Product Information

Changeover from RKP to RKP-II

Sizes 63, 80 and 100 cm³/rev

Advantages and characteristics of the new radial piston pump RKP-II compared to the previous RKP design

Figure 1: Noise pressure levels of the RKP-II with load sensing compensator J1 at $n = 1500 \text{ min}^{-1}$ and $Q = Q_{max}$

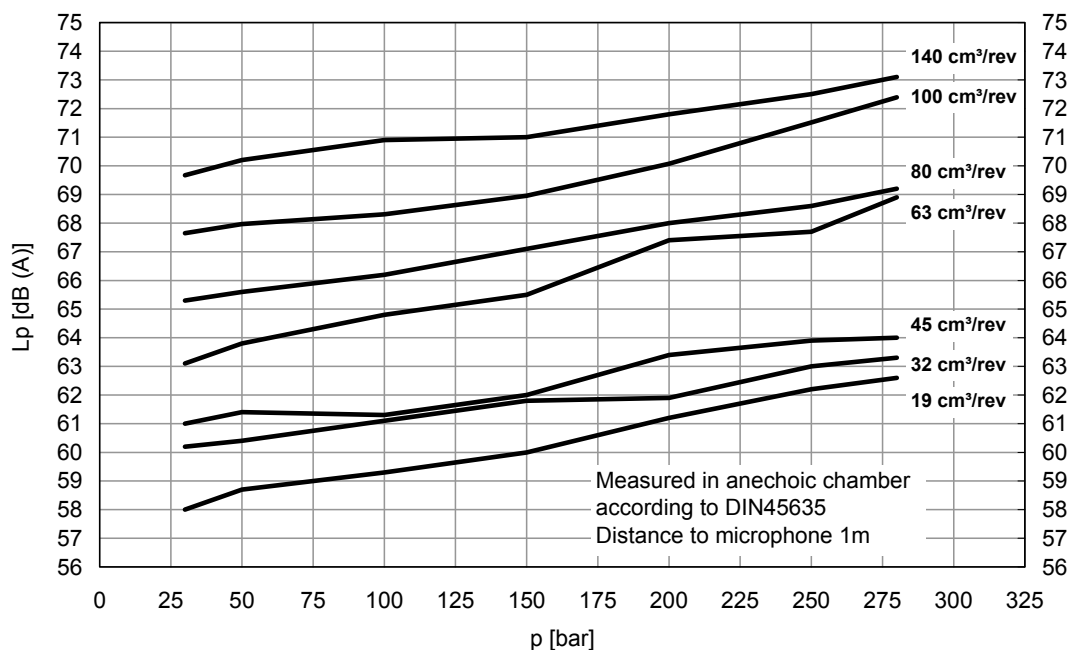
When compared to its predecessors, the acoustic power of the RKP-II has been reduced by 50 to 60 %, depending on the duty point. With this improvement, RKP-II contributes to machine builders efforts to fulfill the EG standards with regards to noise (2003/10/EG). The noise pressure levels of the different sizes are shown in Figure 1.

Figure 2: Comparison of the suction sides of RKP-II and the previous design RKP

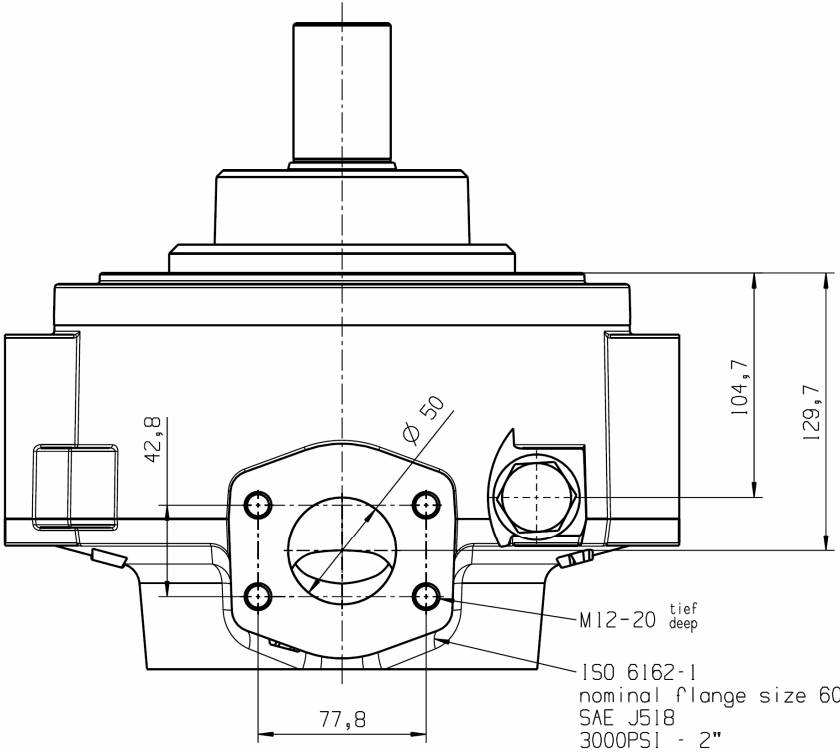
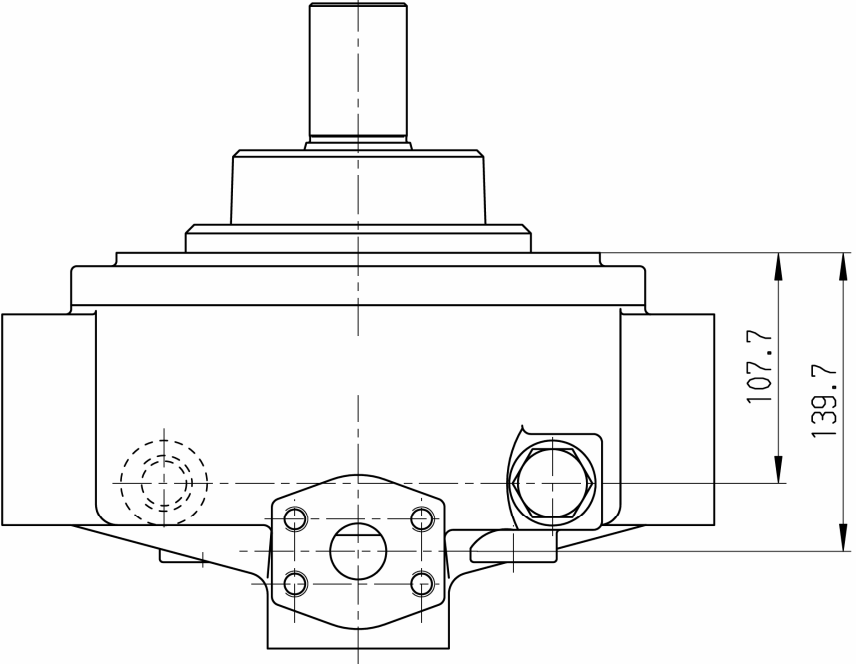
The position of the fluid ports on sizes 63, 80 and 100 cm³/rev has changed by up to 10 mm when compared to the RKP. The drawings shown in Figures 2 to 4 set out the new dimensions when compared to those on the previous RKP. Dimensions which have not changed have been omitted from this representation.

2.2 Size of the Suction Port

For the sizes 63, 80 and 100 cm³/rev, the suction port was enlarged to SAE 2". This enables the connection of a 2" suction pipe without the requirement for a reducing piece as needed previously. The sizes of the pressure port and the leakage ports remain unchanged.

The suction port is often connected to a solid pipe that has to match in position and size a hole in the tank cover. In this case, a suitable adapter can be used to compensate for the different flange sizes and the offset. The suction pipe must then be shortened by the thickness of the adapter. Information on such adapters are available upon request from Moog.

Figure 5: R1-type compensator of the RKP-II, sizes 63, 80 and 100 cm³/rev

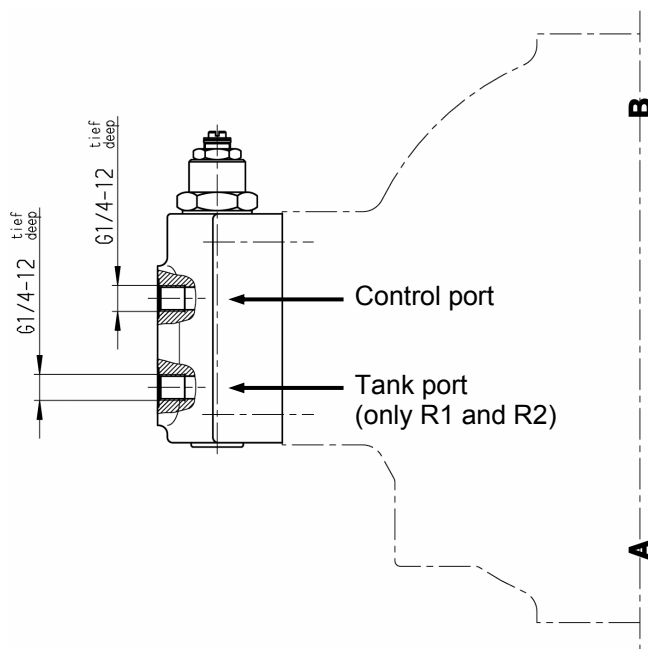
The control port connection has been changed from M 12x1,5 to G 1/4. The tank port connection (only existent in R1 and R2-type compensator) has been changed from M 14x1,5 to G 1/4, too. The position of the ports in the compensator housing remain unchanged. As an example, Figure 5 shows the R1-type compensator with the new port connections.

Fittings with G threads are available for all recommended control hose sizes. An additional adapter fitting is no longer required.
